Responses to Reviewers' Comments

on the manuscript entitled ' Inclusion of the subgrid wake effect between turbines in the wind farm parameterization of WRF ' submitted to Geoscientific Model Development .

Figure12 Comparison of wind energy distribution in wind farm area for (a) the new parameterization scheme; (b) the original parameterization scheme; (c) their difference.

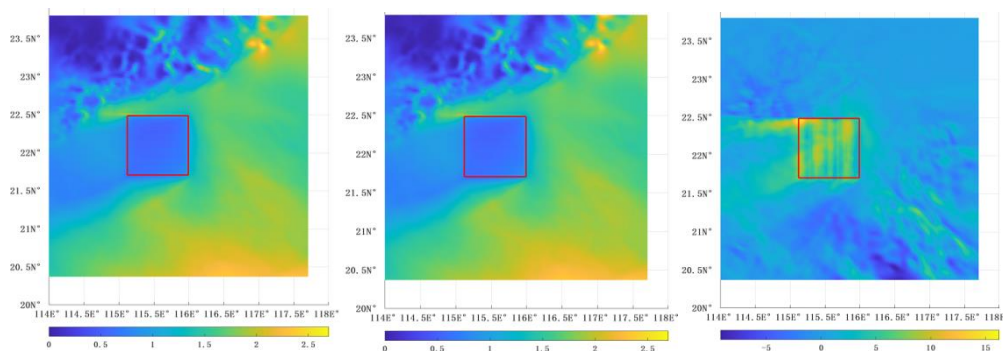
- Fig. 12 shows the average wind power generated by the farm after 3 days. In the presence northeasterly flow, as the case here (Figure 10), the boundary grid cells along the northern (top) and the eastern (right) sides experience the strongest wind, especially the ones along the right boundary. The turbines in the grid cells along the northeastern boundary all produce maximum power with the default Fitch scheme because there is no sub-grid wake effect in Fitch. By contrast, with the proposed modification, some of the turbines in this "ribbon" experience losses. Therefore I expect the Fitch run to produce more power along the northeastern edge. Instead, the exact opposite happens! Also, I would expect to see large differences in the middle and towards the outer edge of the farm (southwestern end), because the inclusion of wake effects should create more differences further into the farm. Instead, the two simulations are basically identical except for the northeastern band, where the modified Fitch scheme somehow produces more than the original for the most upstream rows! In addition, the new scheme generates an astonishing double power than the original scheme. This is highly suspicious.

- The total power generated is very small in both runs. With an installed capacity of $3 \text{ MW} \times 25,600 = 76,800 \text{ MW}$, a production of 11,639 MW and 5703 MW for the modified and original scheme, respectively, correspond to a capacity factor of only 15% and 7%. Why is it so low?

- To make things worse, the energy left in the farm (Figure 11), a weird concept per se because we would need to know over how many levels and how many hours it was calculated, is larger for the simulation that extracted more power, i.e., the one with the new scheme. I find it hard to conceptualize how higher power extraction also leaves more power behind, everything else being equal. Perhaps the authors need to look over a larger domain than just the wind farm area?

- Version 4.3 of the WRF has been utilized to re-run the experiment, and the new outcomes are assessed. The analysis now uses the time-averaged outcomes for the last six hours of the simulation, rather than the snapshot results. From our current results, the total power of the wind farm is now closer to the expected under the original and new parameterization schemes, but the spatial distribution of the power is different. In the back row grid of the wind farm, the total power in the new scheme is lower than in the original scheme due to the added wake effect, which is realistic. However, at the right edge of the wind farm, the power at the edge of the grid is slightly higher than in the original scheme due to the higher incoming wind speed calculated in the new scheme, even though the wake effect is taken into account.

- The low wind power output stems from the wind farm's large size and the subsequent wake impact on internal turbines from turbines at the edge. This lowers the internal turbine output and ultimately affects the total power output. Perhaps if not every neighboring grid in this wind farm had turbines set up, but instead there exists a portion of the grid where no turbines are set up to provide some space for wake recovery, the normalized power of the whole wind farm would be much higher.

- We have already addressed this question in the first point. For reference, we provide results for a more extensive area (Figure 12). It has been discovered that the new parameterization scheme does, in fact, decrease the extraction of wind kinetic energy within the wind farm area. As a result, this effect impacts the downstream portion of the wind farm, leading to an increase in downstream wind kinetic energy. The observed phenomenon is not solely attributable to the decrease in turbine power, as the power shift within the wind farm is negligible in the updated findings. It seems that the downstream alteration is more likely a result of heightened turbulent kinetic energy comparing to the original parameterization. This enhances the entrainment of momentum in the wake and upper atmosphere, in other words, strengthens the turbulent transport process of mean kinetic energy from the ambient region to the wake region.
